## ADDENDUM No. 2

**Project: 2024922**  
**South Jones High School Athletic Buildings**  
**Jones County School District**  
**Laurel, Mississippi**

The following additions, changes, clarifications, and substitutions to the drawings and specifications, dated June 25, 2025, are to be included as part of the contract documents. Acknowledge receipt of this addendum by inserting its number and date in the proposal form.

3  
A7.2 **LOCKER SECTION**  
SCALE: 1-1/2" = 1'-0"

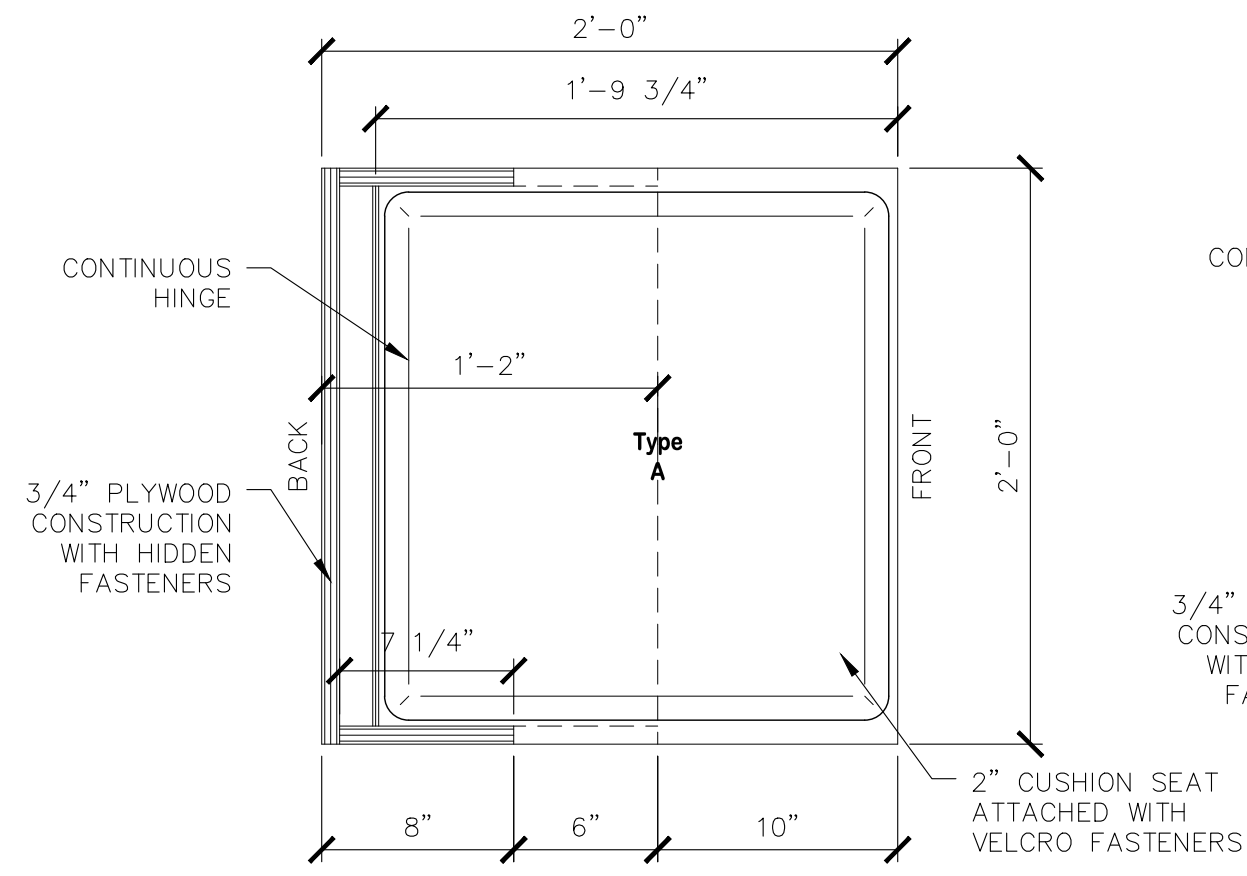
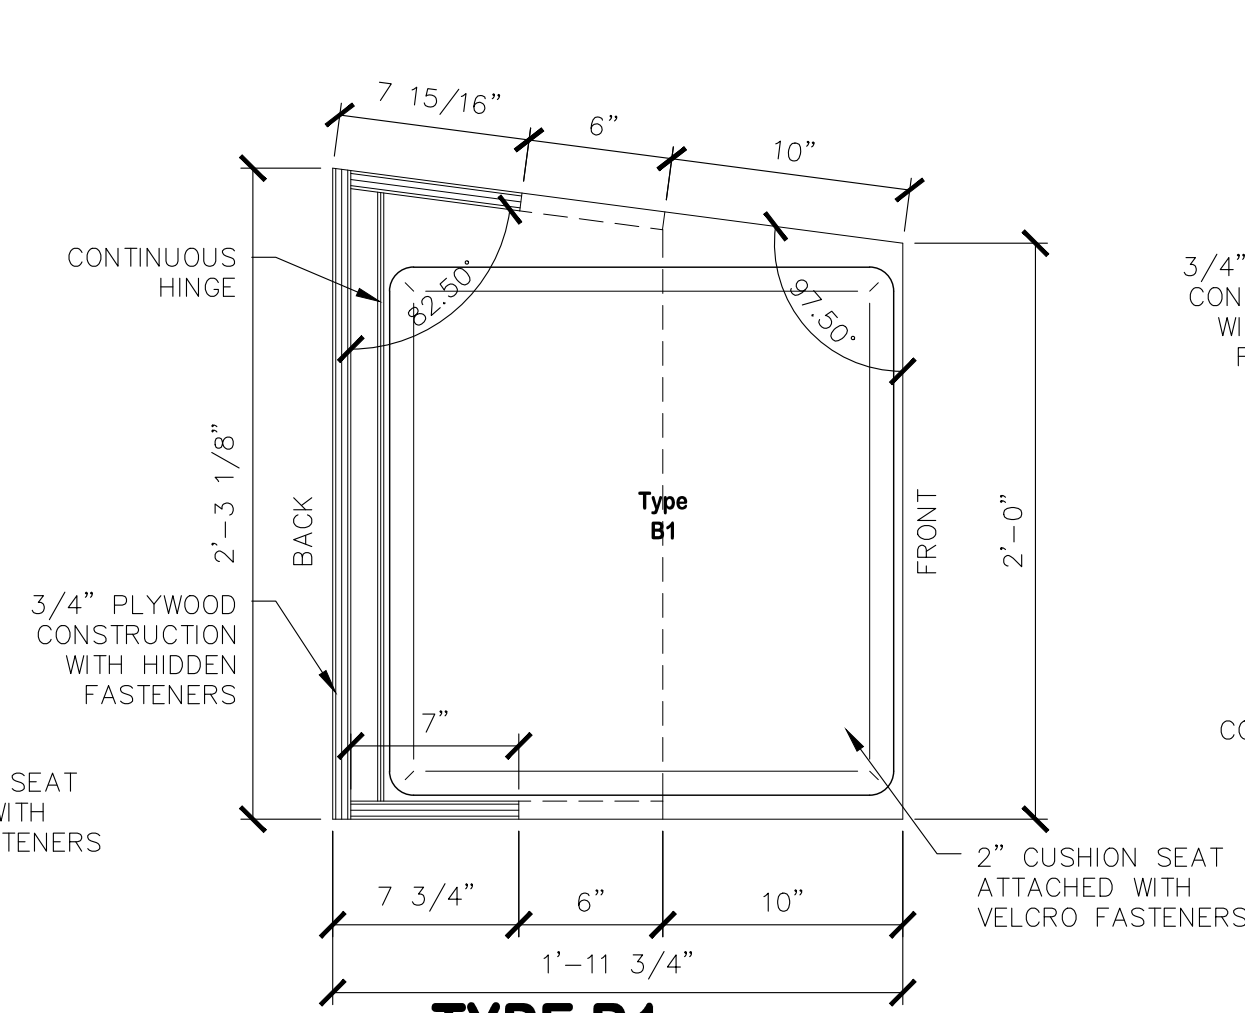
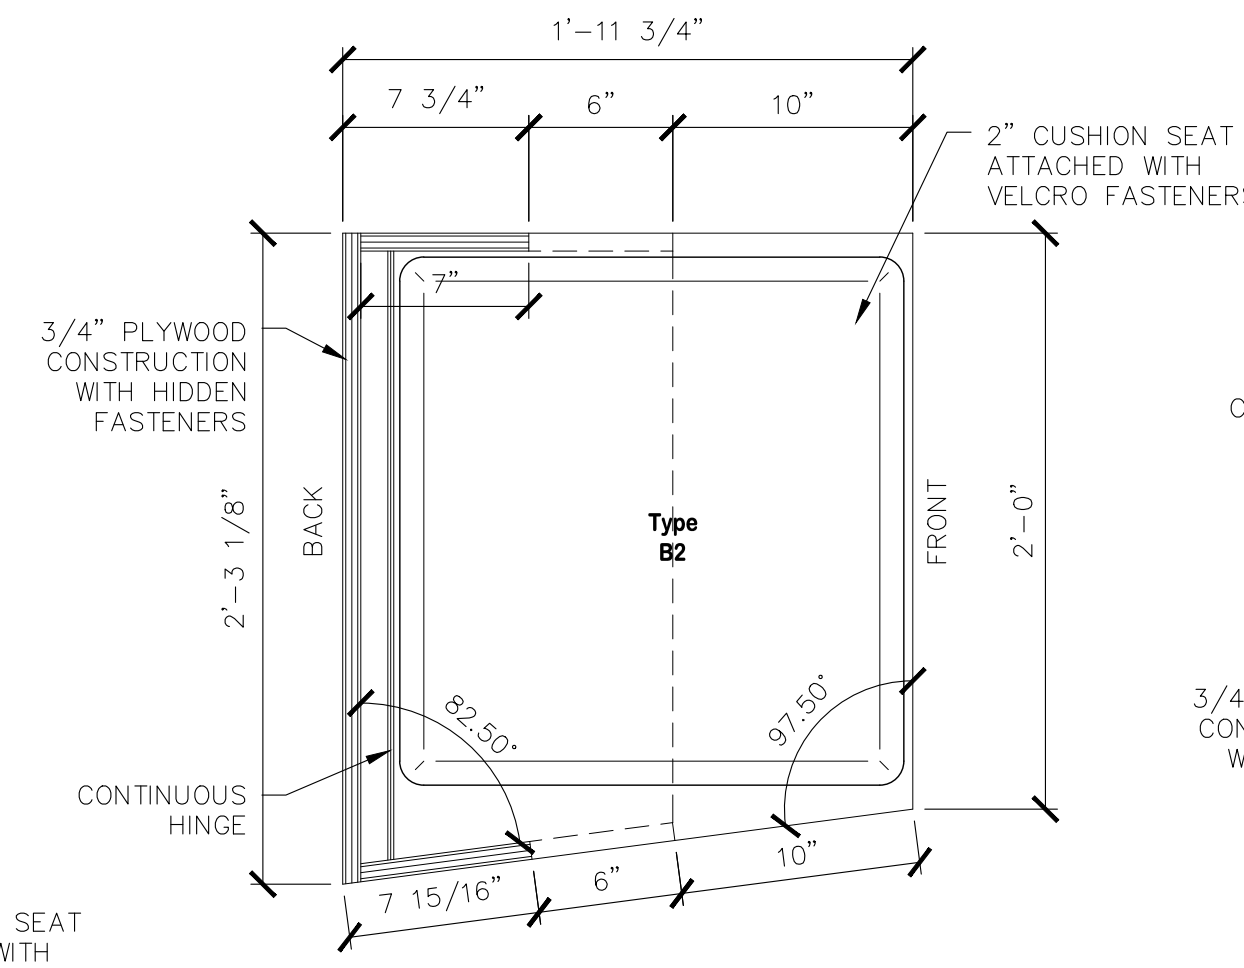
- Item No. 2. Refer to Project Manual – Add the enclosed Section 01 18 03 Project Utility Sources.
- Item No. 3. Refer to Project Manual – Add the enclosed Section 10 51 16 Athletic Wood Lockers. Athletic Wood Lockers shown on A7.1 and A7.2 shall be per enclosed Section 10 51 16 Athletic Wood Lockers.

- Item No. 26. Refer to Sheet A1.33, Plan 1/A1.33 and 2/A1.33, Note 5 – Refer to enclosed A7.2 for Lockers' Layout and Details.
- Item No. 27. Refer to Sheet A1.33, Plan 1/A1.33 and 2/A1.33, Note 6 – Coaches Lockers shall be Type A as shown on A7.2.
